**SOIL, GEOLOGY, AND GEOLOGIC HAZARD STUDY  
STERLING RANCH FILING NO. 5  
PARCEL 16  
EL PASO COUNTY, COLORADO**

November 22, 2022

DRAWN	L.L.
CHECKED	
DATE	11/15/22
SCALE	AS SHOWN
JOB NO.	222159
FIGURE No.	3

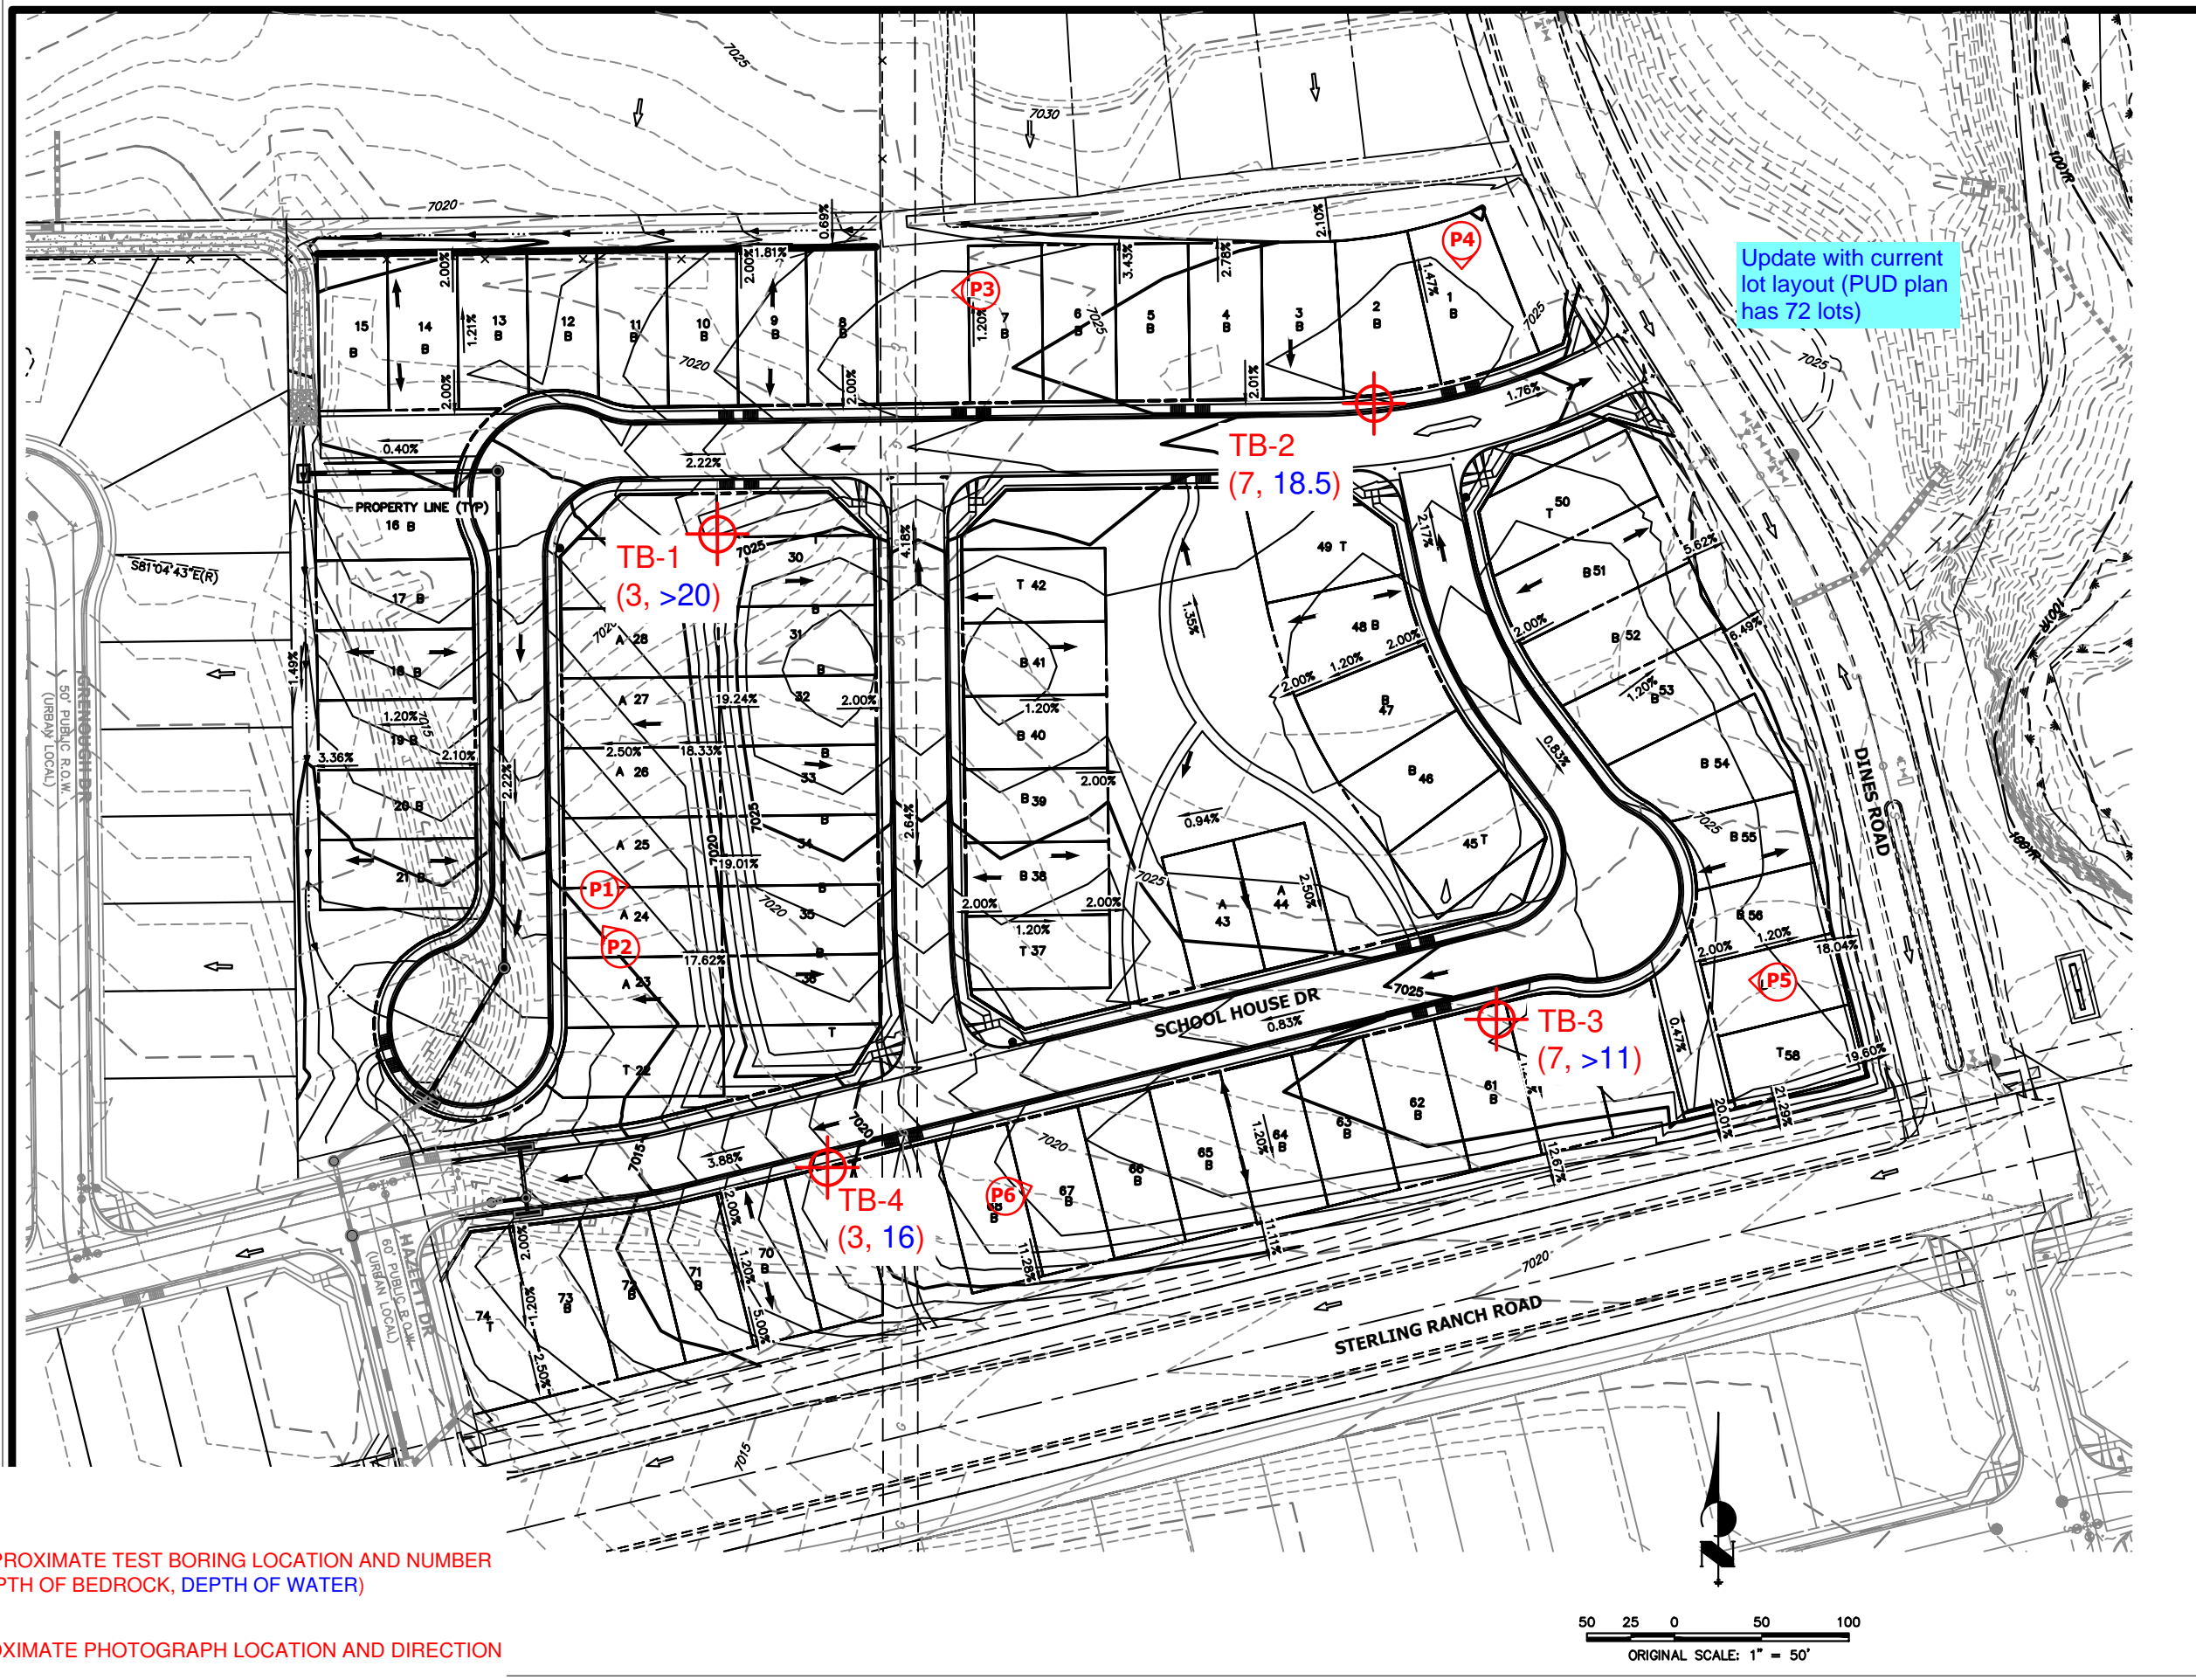
Update with current lot layout (PUD plan has 72 lots)

GEOLOGY/ENGINEERING GEOLOGY MAP  
STERLING RANCH FILING NO. 5  
PARCEL 16  
COLORADO SPRINGS, CO.  
FOR: CLASSIC SRJ

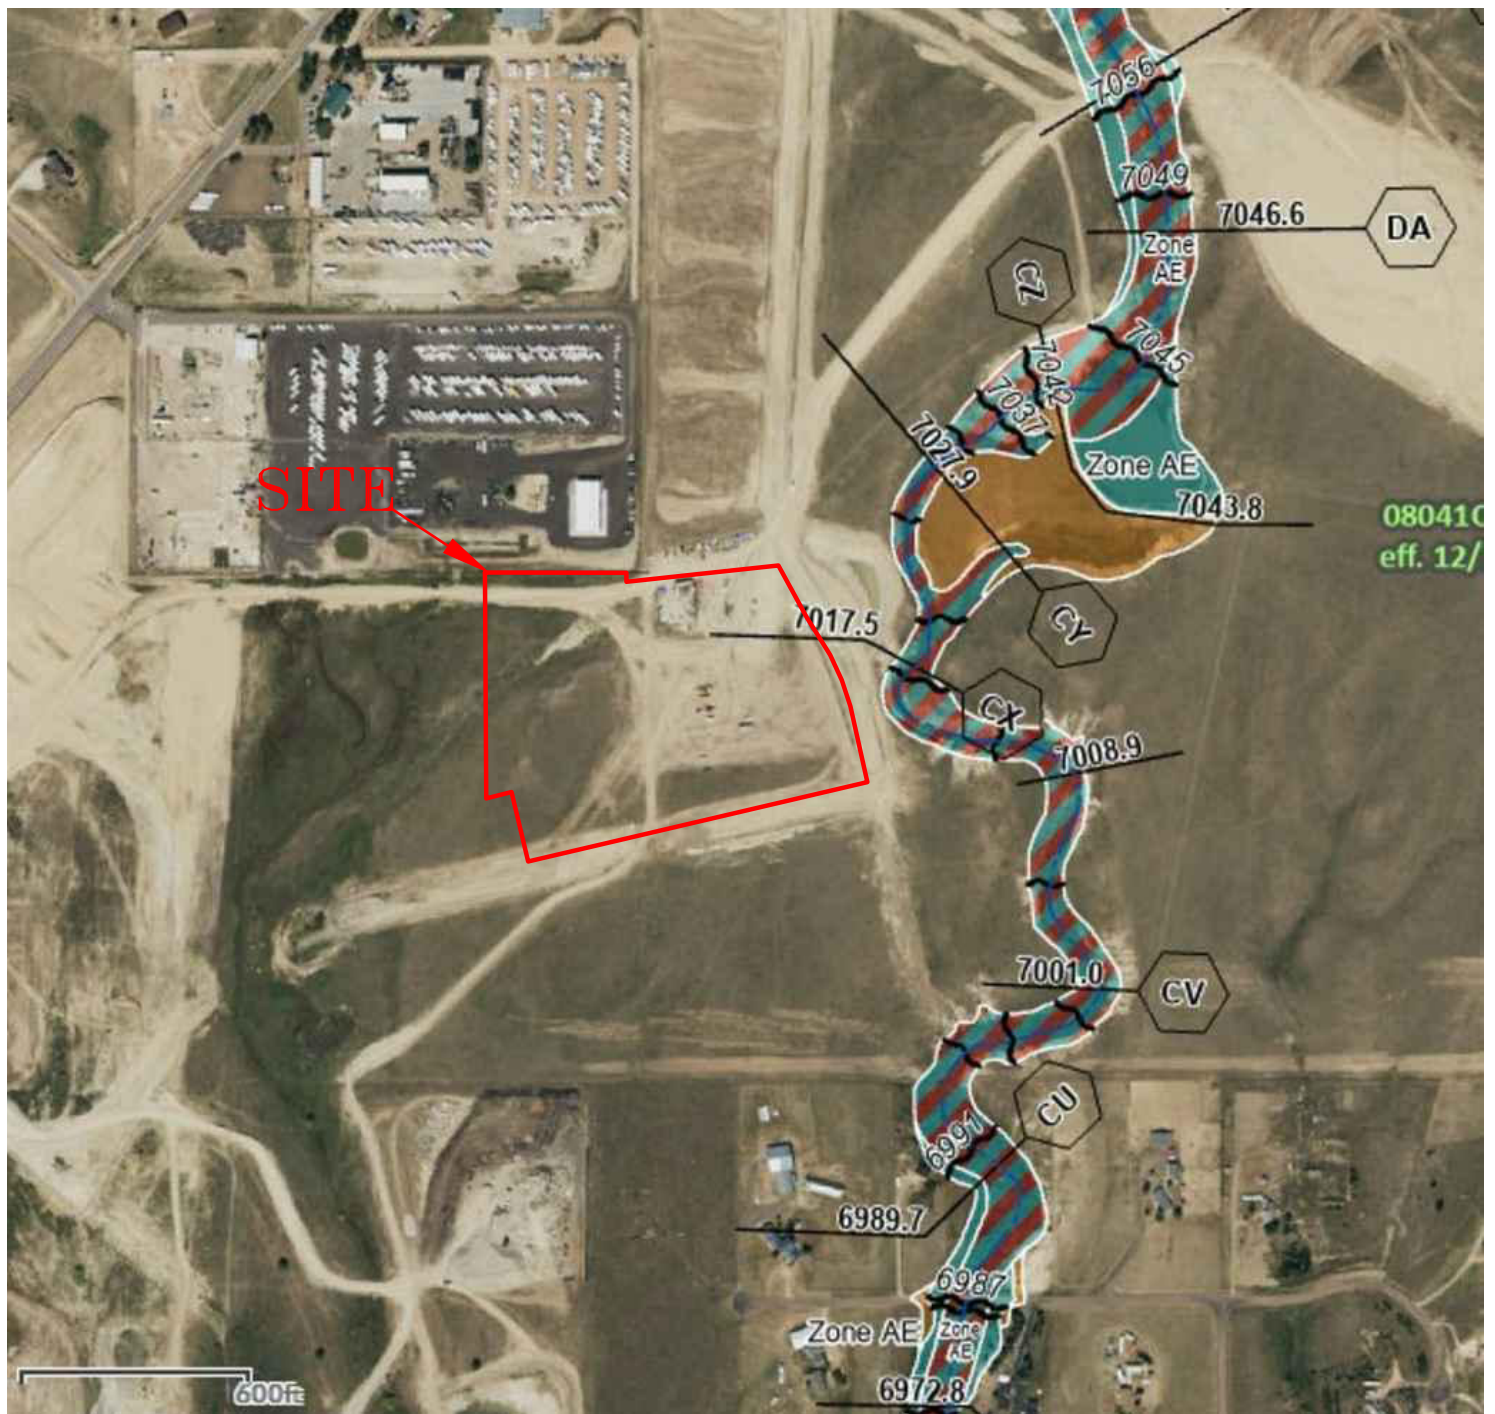
please clarify notes on preliminary plan to identify constraint for these lots and the mitigation....
